AIA HQ RENEWAL COMMISSION OF FINE ARTS SHIPSTEAD-LUCE ACT CONCEPT REVIEW JUNE 16, 2022

April Concept Review Response Narrative

Since our April Concept Review, the AIA HQ Team has worked to address each of the CFA's comments and to incorporate responses into this resubmission.

Site Plan Progress

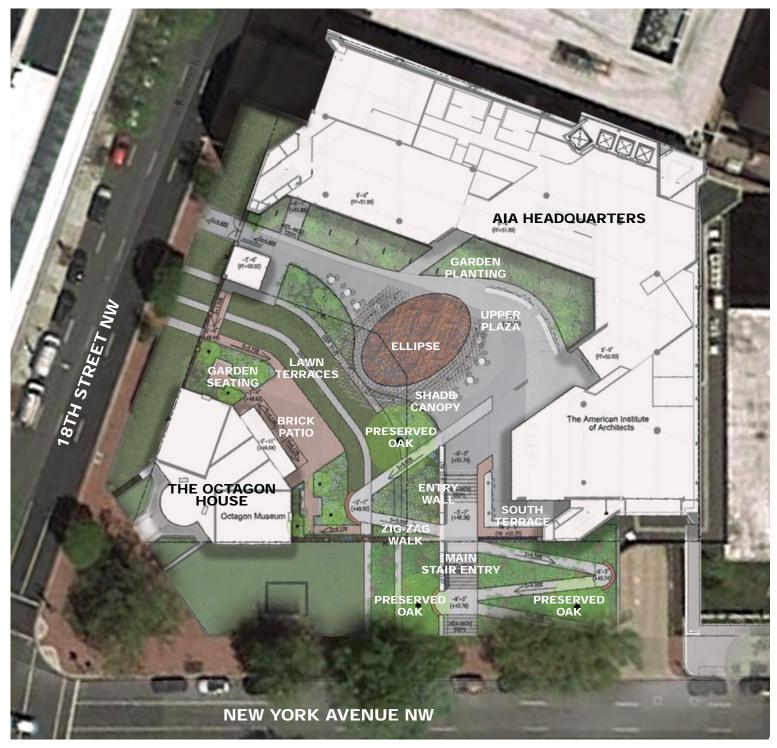
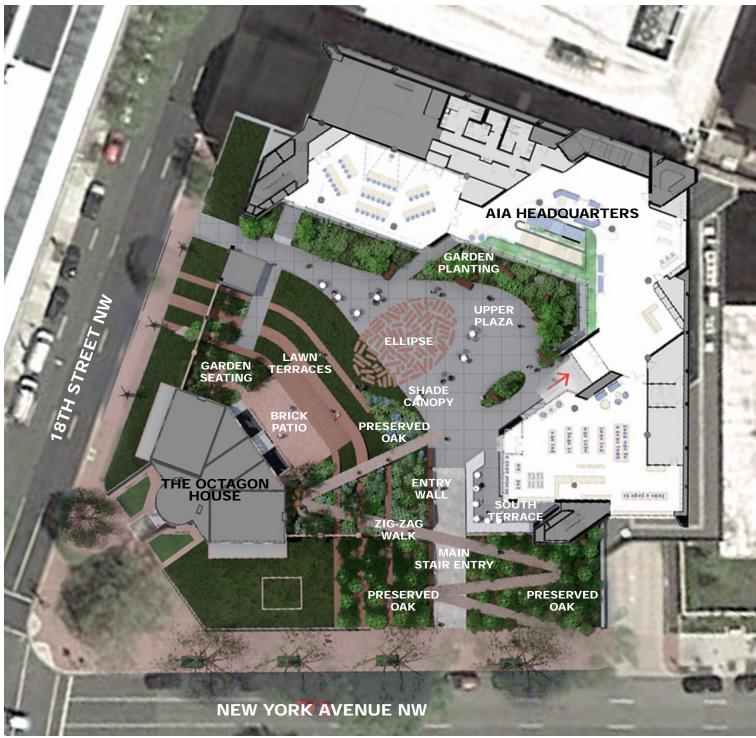
- 4. This proposed move to repurpose a significant portion of the existing brick pavers on site aligns well with another CFA promotion of "materials that support the AIA's message of sustainability, not just by offsetting the resultant carbon load off-site, but through careful study of the materials' intrinsic experiential and sustainable qualities and their visible on-site presence." The Team no longer proposes a concrete wall at the entryway but rather rough sandstones to engage more a more timeless, intrinsic arrival experience which will carry visitors through the building. The sandstone's variation and tactility offer a natural wayfinding strategy to embody universal design principles. The team is also now proposing a more-sustainable wood zigzag 'boardwalk' that will run from New York Avenue through to the Plaza to further enhance the warmth and natural feel of Site materials. In plan, the proposed wood zig-zag boardwalk has shifted to further avoid the (3) heritage trees and the wood

material will significantly lessen any impacts to the trees' structural root zones. The boardwalk planks' details will be carefully detailed and coordinated to ensure a comfortable experience for visitors with mobility devices. See bottom right image.

Site Circulation

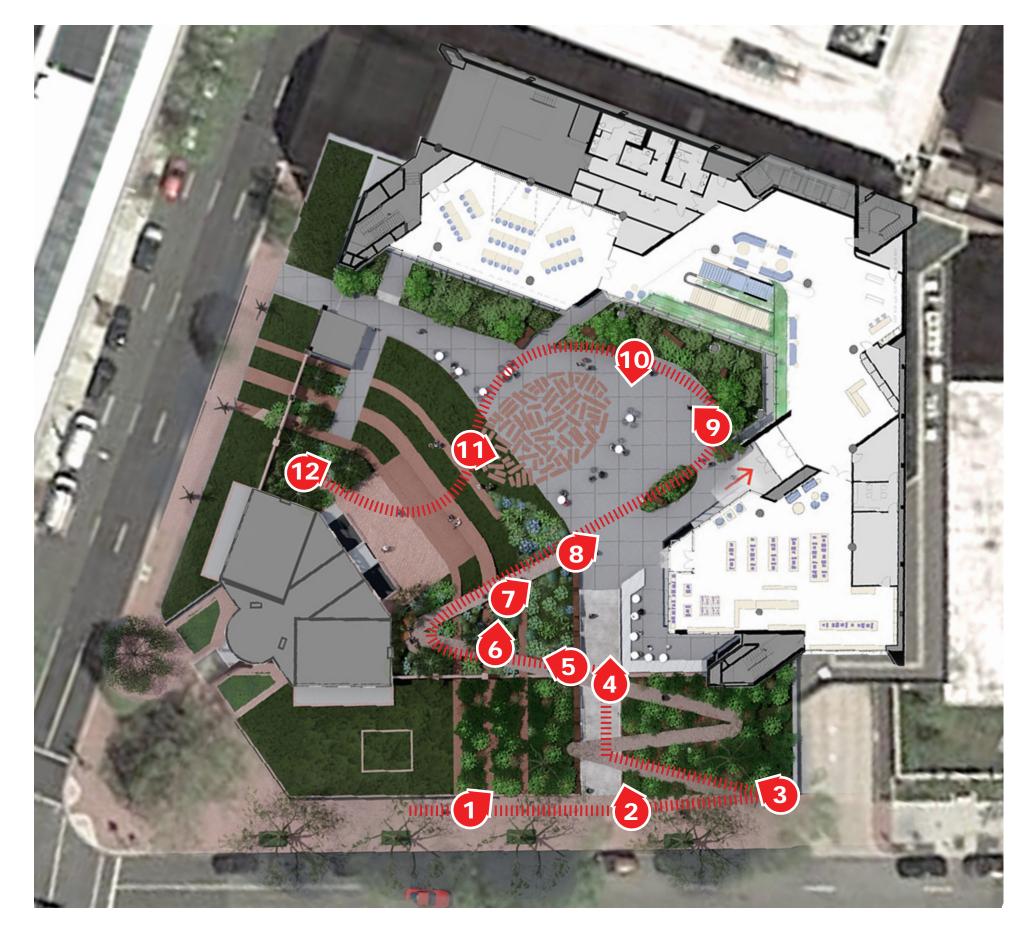
- 1. Regarding the Site Design, we organized and held a design workshop with Karen Braitmeyer, FAIA to improve the Site's universal design characteristics and equitable, accessible planning and to honor the commission's recommended "consultation with community of mobility-impaired people regarding the best accessible routes through the site". We closely explored the "route from 18th Street into the site as a key piece of the entrance sequence that can also connect to routes between the upper plaza and the lower garden behind the Octagon." While our existing conditions at the entrance itself off 18th street offer limited width between the Headquarters Building and the Historic Smoke House of the Tayloe Estate, the Team worked to widen and improve the site circulation within the plaza from that entrance, particularly for the path of travel towards the Octagon's lower garden and other gathering spaces. See page 9.
